## SERVICE BULLETIN

**Title:** 23XL Lifting Warning Label  
**Models Affected:** 23XL

**Number:** C9622

To inform the field of the proper method of lifting disassembled components of screw compressors in the field and of a program to provide lifting warning labels for all 23XL compressors.

Figure 1

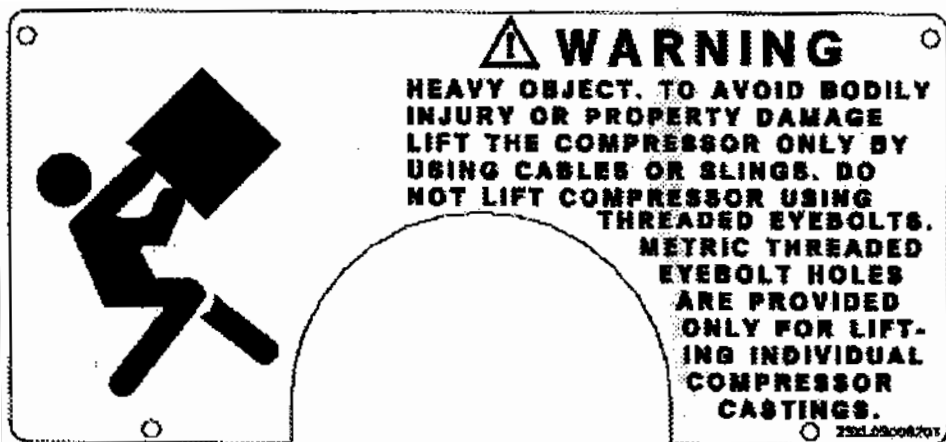
Lifting warning labels (part # 23XL05006201) for all 23XL chillers have been shipped to the Carrier service managers. The label (depicted in [Figure 1](#)) is to be wire tied on the oil supply line at the top of the discharge casing or can be molded to the shape of the casting and adhered by double sided tape around the lifting hole (as depicted by [Figure 2](#)).
